California High-Speed Rail Authority

RFP No.: HSR 13-57

**Request for Proposal for Design-Build
Services for Construction Package 2-3**

Book IV, Part G.1 – Design Variance Report

DRAWING NO.
CB1825

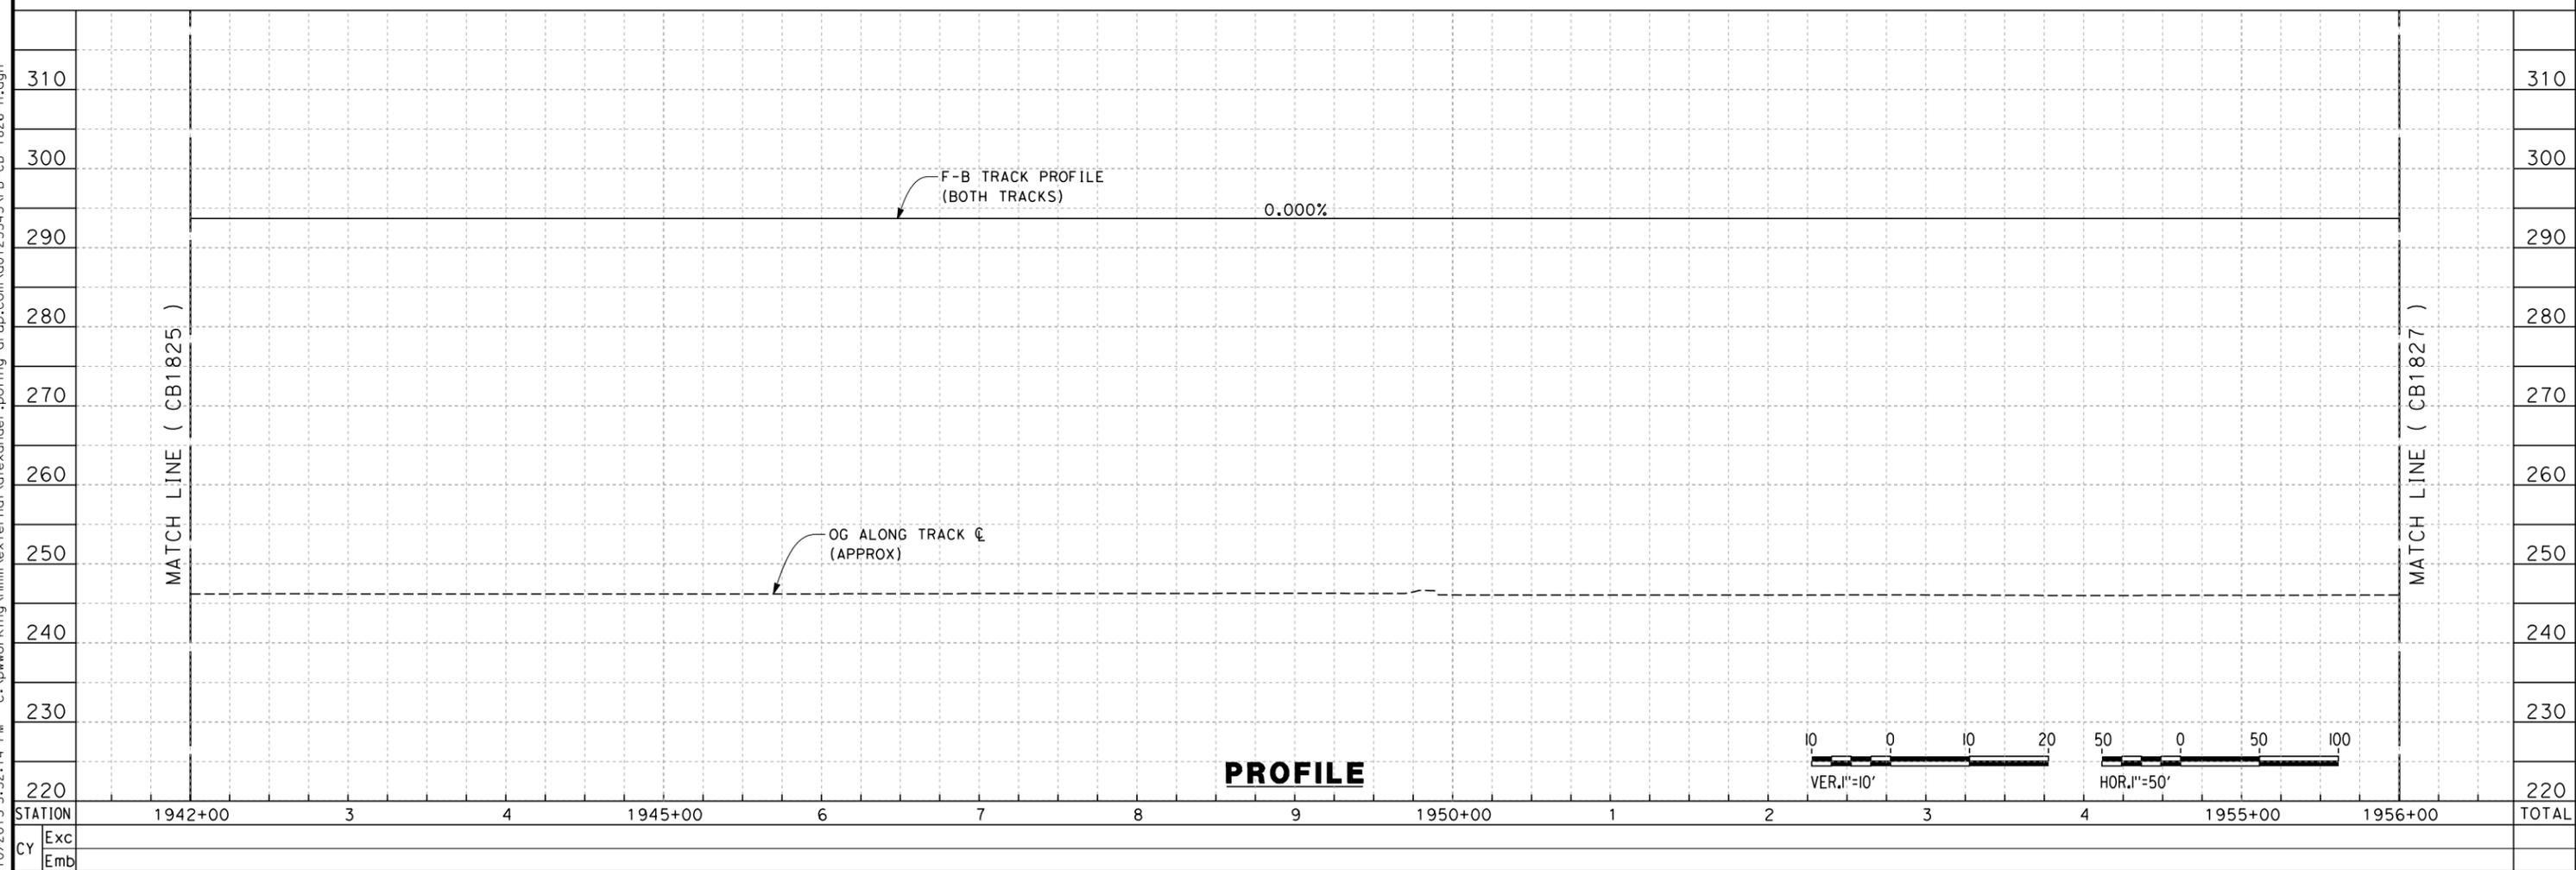
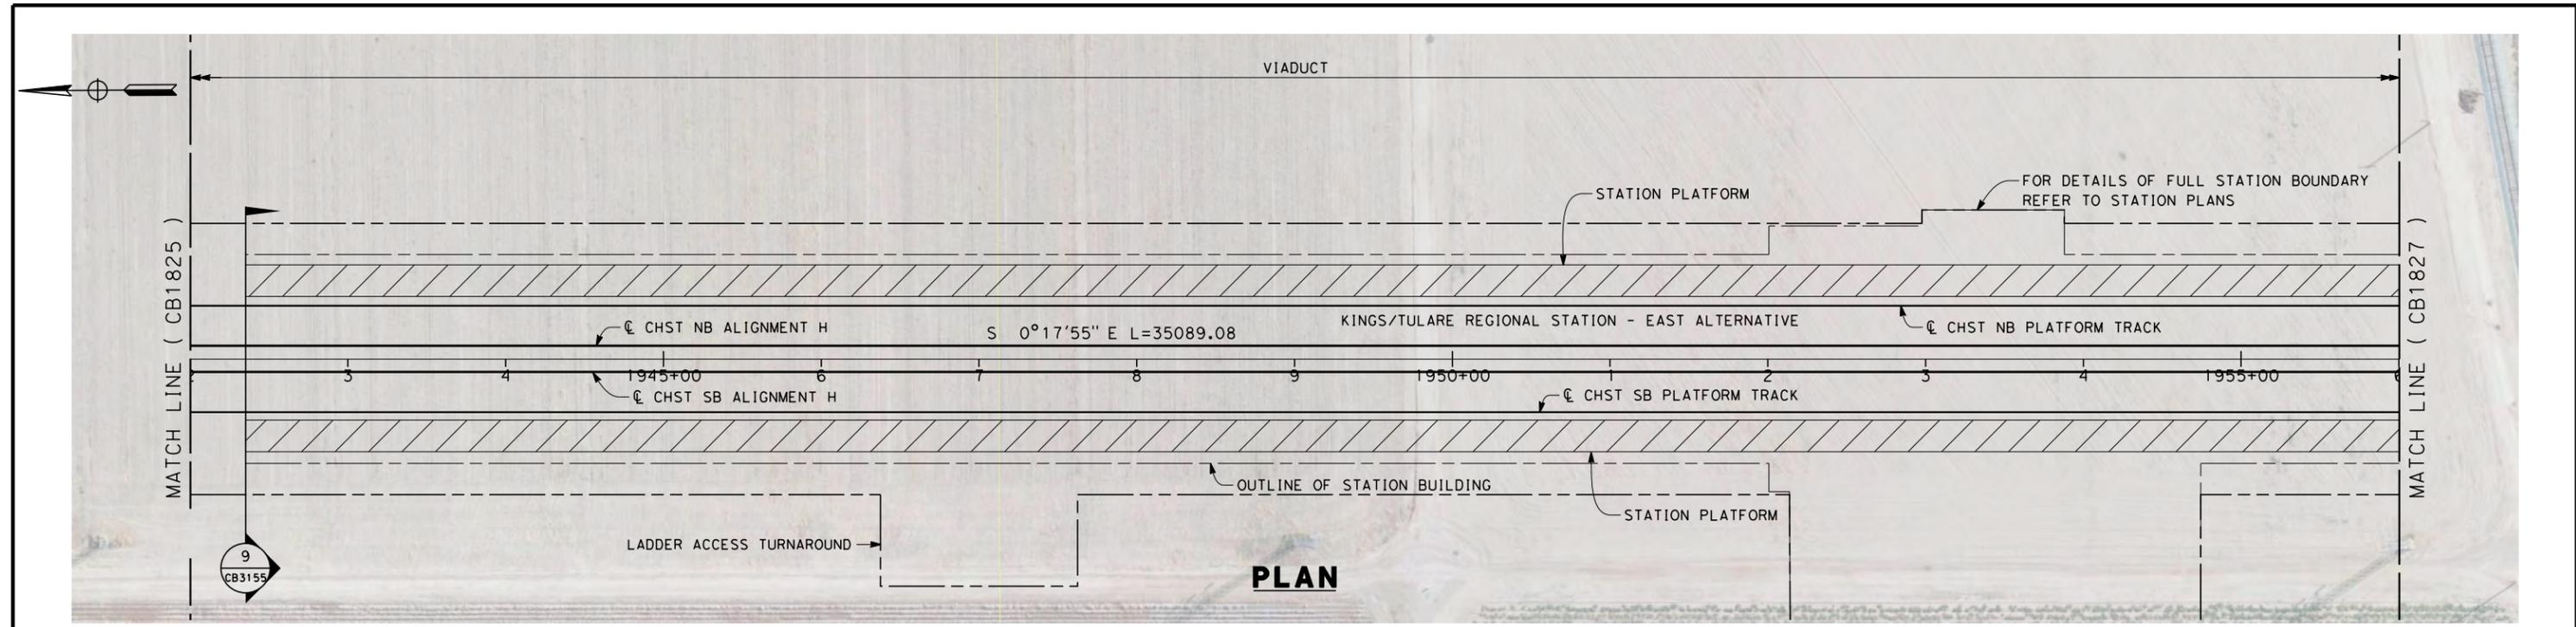
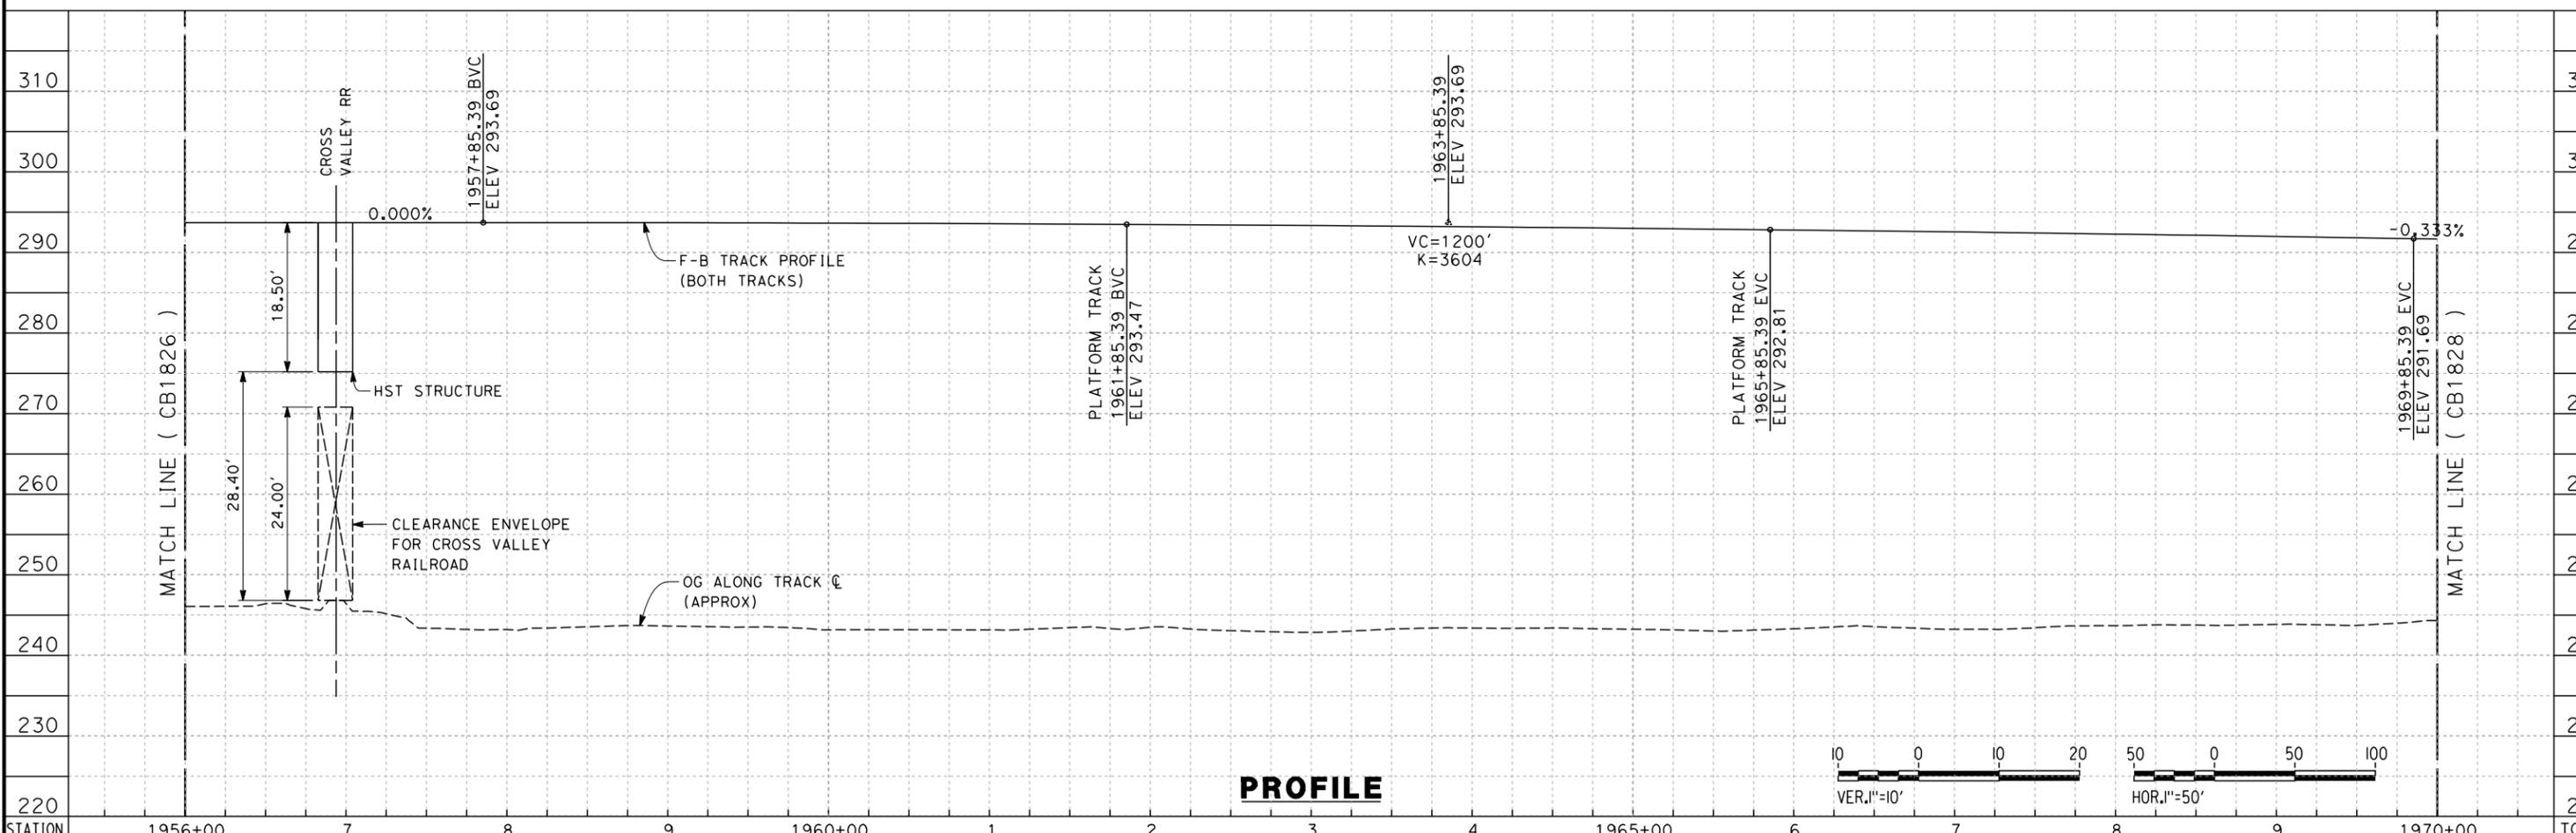
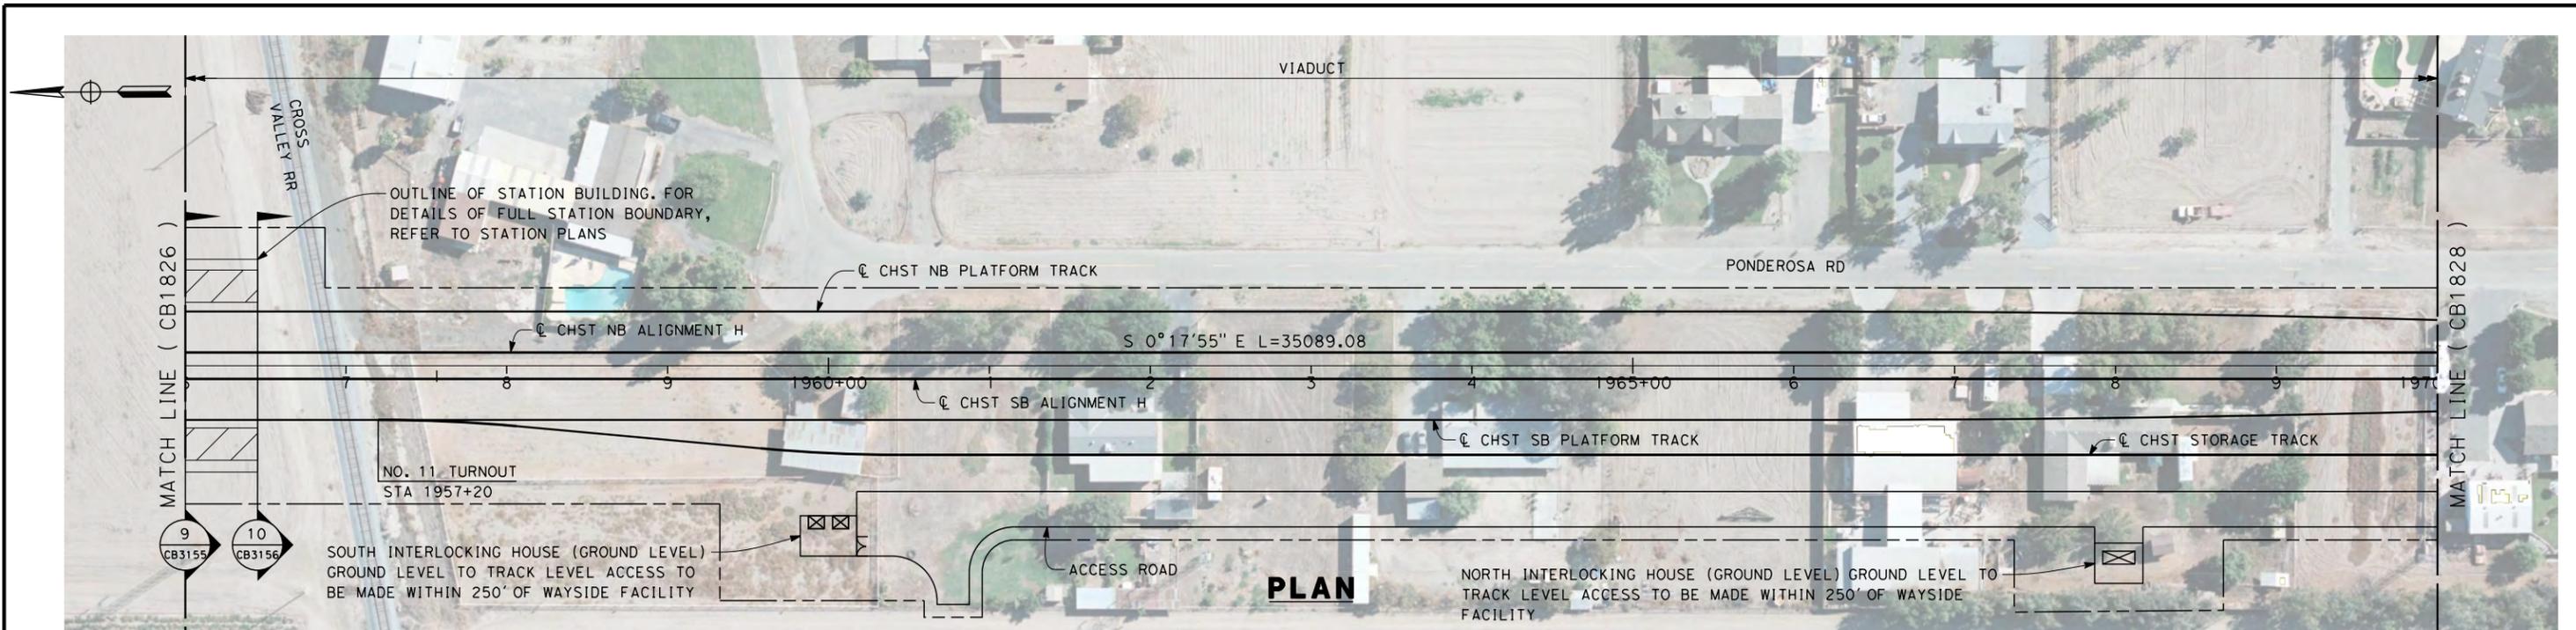
<p>REASON FOR REQUESTING A VARIANCE</p>	<p>The horizontal spiral in the return curve of the 110 mph turnout is coincident with the beginning of the vertical curve of the station tracks at all four quadrants. This does not provide the exceptional 1.5 seconds of attenuation time (242 feet) indicated in TM 2.1.2 Section 6.1.1 or the minimum 100 feet called for in TM 2.1.2 Section 6.1.7.</p>
<p>JUSTIFICATION FOR VARIANCE</p>	<p>Kings/Tulare Regional Station is raised on a viaduct and requires vertical curves north and south of the station to lower the tracks back to grade. The vertical curves are on the mainline between the turnout for station tracks and the platforms. This allows for appropriate attenuation length on the mainline and a 0% grade throughout the station.</p> <p>The 15% Record Set design provides the standard 6,000-foot station tracks at 110 mph (from point of switch to point of switch). For this length the</p>

<p>approaching the station would need to reduce speed earlier due to the turnout's location farther from the station. A design variance to Directive Drawing 2.1.3 – Interlock A would be required for the nonstandard position of the station turnouts.</p> <p><u>South of the Station</u> Desirable attenuation can be provided between the return curve spiral and the vertical curve of the station tracks south of the station by sliding the station track turnouts 610 feet south. The mainline vertical curve south of the turnouts would achieve the minimum length (1,200 feet), and the four-track viaduct would require lengthening by 610 feet. The shift south would also require relocating one system site and lengthening the access road. The distance between the station turnouts and station crossovers would decrease by 610 feet.</p> <p><u>North of the Station</u> Desirable attenuation can be provided between the return curve spiral and the vertical curve of the station tracks north of the station by sliding the station track turnouts 388 feet north. This would require lengthening the four-track viaduct by 388 feet. The shift north also requires relocation of a systems site and lengthening of the access road.</p>

OPERATIONS	None identified
MAINTENANCE	Slab track could be used to mitigate maintenance concerns of providing the station track spiral coincident with the beginning of the vertical curve.
INFRASTRUCTURE	None identified
RAILROAD SYSTEMS	None identified
OTHER	The vertical curve was located coincident with the station track spiral to avoid introducing a segment shorter than the length required to provide minimum attenuation. Ride quality may also be reduced; however, designing the two elements coincident allows the horizontal and vertical moves to occur simultaneously.
